**RE: JD 24 Improvements and Final Engineer's Report Independent Review**

Following the continuance of the Final Petition Hearing for the Jurisdictional Ditch 24 (JD24) improvements on September 23, 2019, you requested RESPEC evaluate the following items:

Figure 1. Clip of Proposed WASCOB and Relative Location of Existing Tile (yellow) from Final Engineer's Report

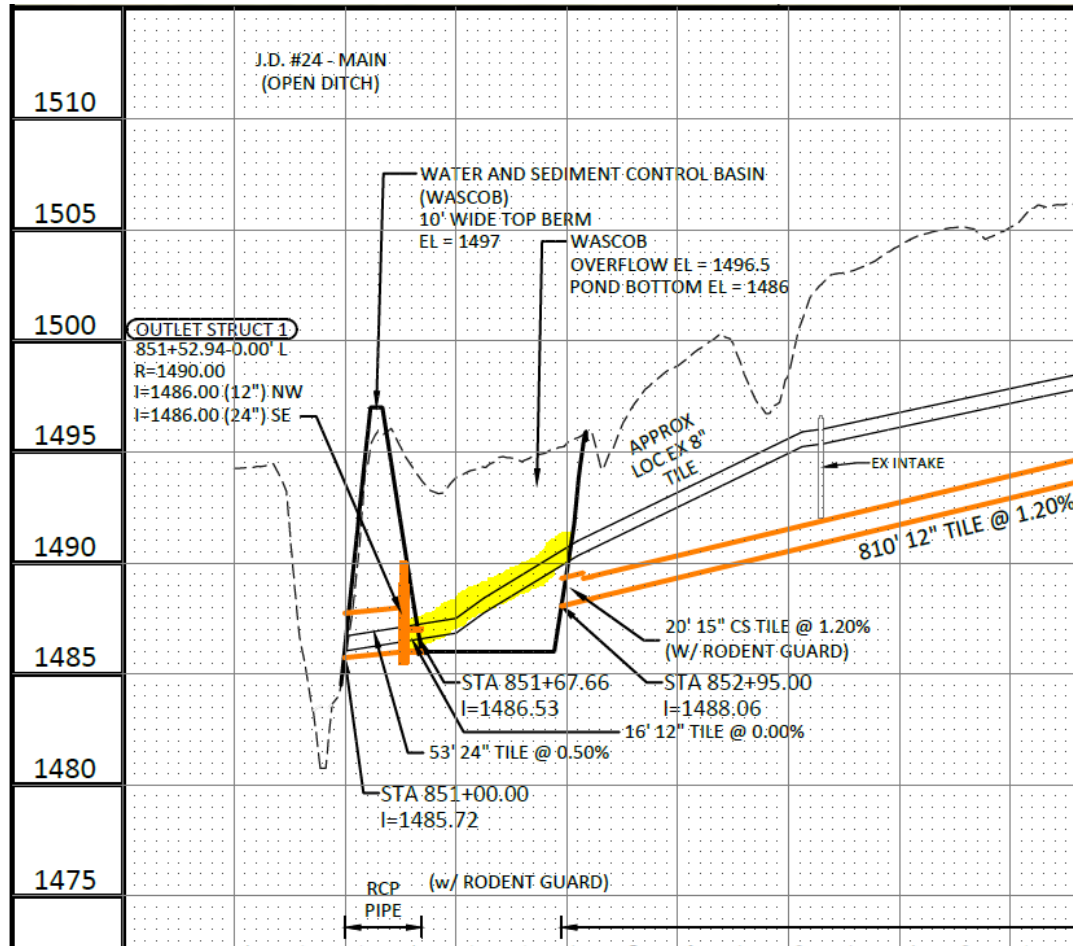
First, we reviewed the proposed plans for WASCOB B included in the 2018 Final Engineer's Report, Sheet 3.01 which shows the profile of the existing drain tile and the proposed grading for WASCOB B. Based on this profile, the existing tile is incompatible with

the proposed WASCOB as it is between 1- and 4-ft above the bottom of the WASCOB, as shown in Figure 1. The existing drain tile cannot remain in place as-is if the WASCOB is constructed.

In order to keep WASCOB B, as proposed and required by the MnDNR, the existing tile must either be re-routed around the basin or broken and allowed to discharge directly into the basin. For the purposes of this evaluation, we have assumed the tile would discharge into WASCOB B. While the Drainage Engineer provided their HydroCAD models of the system, we have evaluated Branch B using EPA SWMM in order to evaluate the existing hydraulics in the current Branch B system as well as the impacts caused by the addition of WASCOB B. The resulting watershed flows from the Branch B SWMM model are different from the HydroCAD models due to the greater detail provided, each inlet and each pipe are included in the model to evaluate the effects of WASCOB B on tile capacity.

The most obvious change is the reduction in peak flow capacity in the mainline Branch B tile. Landowners on Branch B will experience reduced capacity along the mainline Branch B due to the WASC OB affecting the tile outlet hydraulics. The proposed design from the 2018 Final Engineers Report would result in a reduction of approximately 14% of the peak tile capacity. The alternative of combining the proposed WASC OB B with the existing tile worsens the mainline Branch B capacity, causing a reduction of 63% in the peak tile capacity from existing conditions.

Figure 2. FEMA 100-Year Floodplain (FIRM Panel 2706320025B) with Proposed WASCOB (yellow star) and JD24 Outlet (Blue circle)

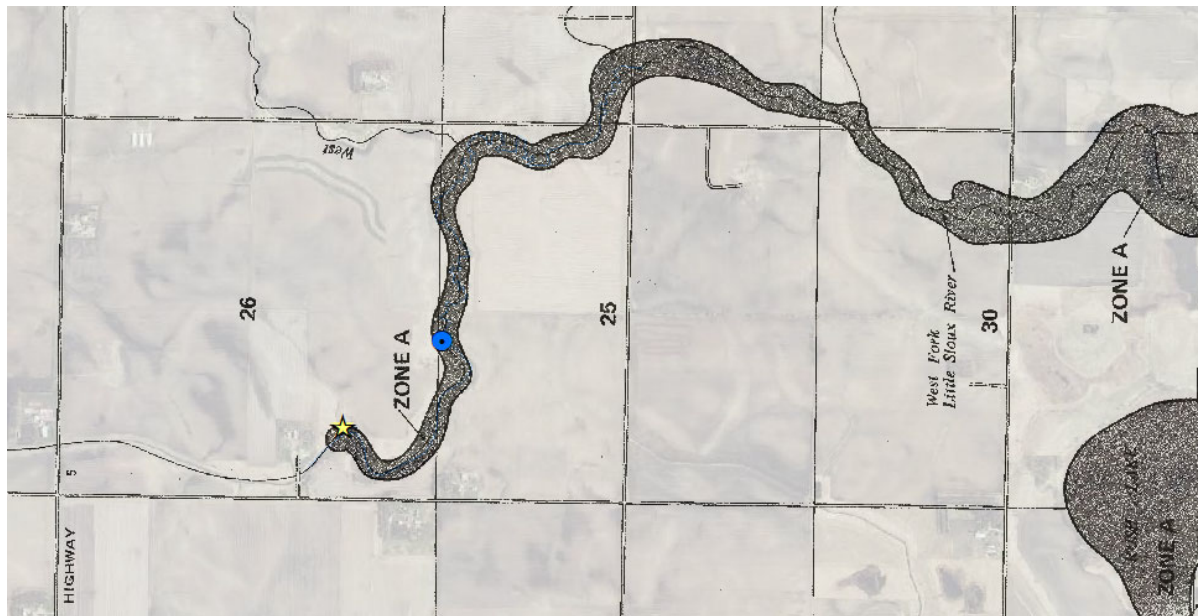
The JD24 system is mapped within the FEMA Special Flood Hazard Area Zone A (AKA the 100-year floodplain) of the West Fork Little Sioux River (Figure 2). Because the proposed improvements are not only altering the hydrology, but also the existing landscape with WASCOB B, we have evaluated the hydraulics at the JD24 outfall using HEC-RAS. Using the HydroCAD flows, modified to include the 100-year event, we developed a HEC-RAS model to evaluate the changes at the outfall due to the proposed improvements. The flows are provided in Table 6 below, taken from the outflow at HydroCAD Node 62R, it should be noted that the HydroCAD models became unstable when analyzing the 100-year event due to high water elevations. In particular, Node 59P (330<sup>th</sup> Ave) has a higher outflow (2,172 cfs) than inflow (1,355 cfs), indicating the model is unable to balance and the HydroCAD results may be invalid. It is recommended that the model be reviewed to increase storage and reduce these instabilities.

The results from the HEC-RAS analysis indicate that the JD24 outfall would experience an increase in water surface elevation of approximately 0.1-foot due to the proposed improvements upstream. At WASCOB B, there is a maximum increase of 0.33-ft due to changes in grading near the JD24 channel.

At the September 23, 2019 Continued Final Public Hearing, there was concern from residents of Sioux Valley Township that this project would increase the flows entering the West Fork Little Sioux River and exacerbate existing flooding concerns. The HydroCAD and HEC-RAS analyses both confirm that additional water would be sent downstream should this project be implemented.

Figure 3. Location of proposed JD24 Improvements (yellow) and National Wetland Inventory wetlands (green)

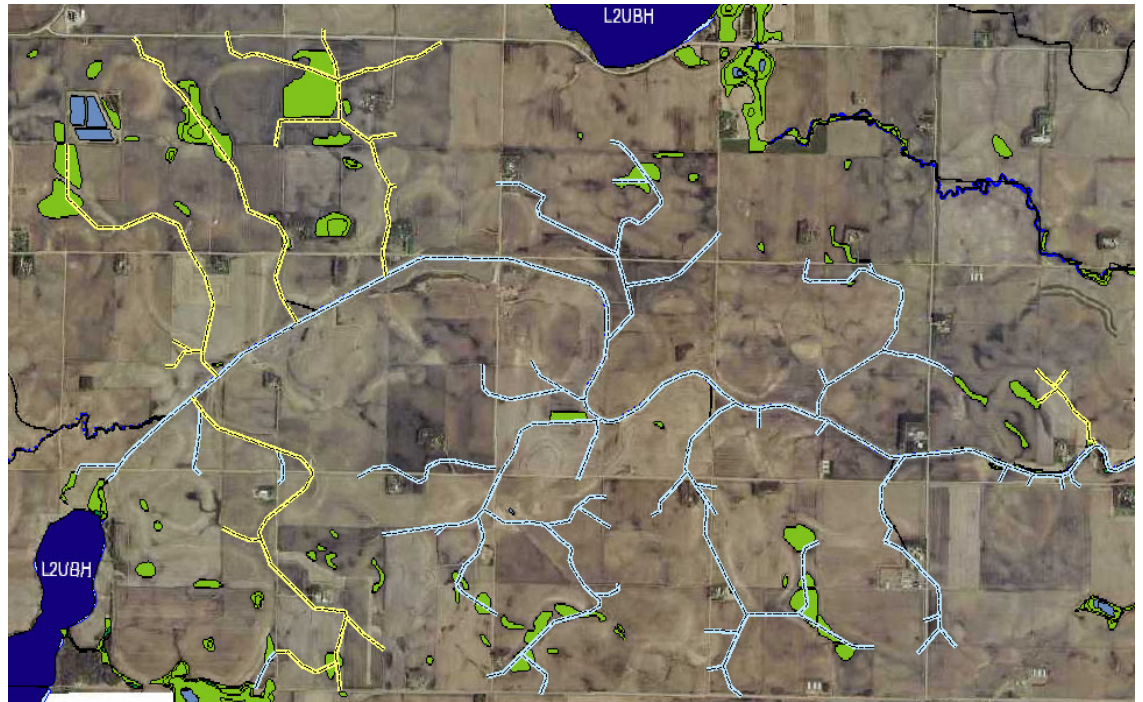
The proposed JD24 improvements will impact 12 wetlands, in particular the wetland at the outfall of Branch B, where the proposed WASC OB B will be located. This wetland will be filled and the hydrology altered, making it likely that the County would need to purchase replacement credits from nearby wetland bank at a cost of roughly \$35,000 per acre of wetland credit. With a 2:1 replacement ratio, this single impact could cost over \$50,000, including the state-required withdrawal fee of \$4,000.
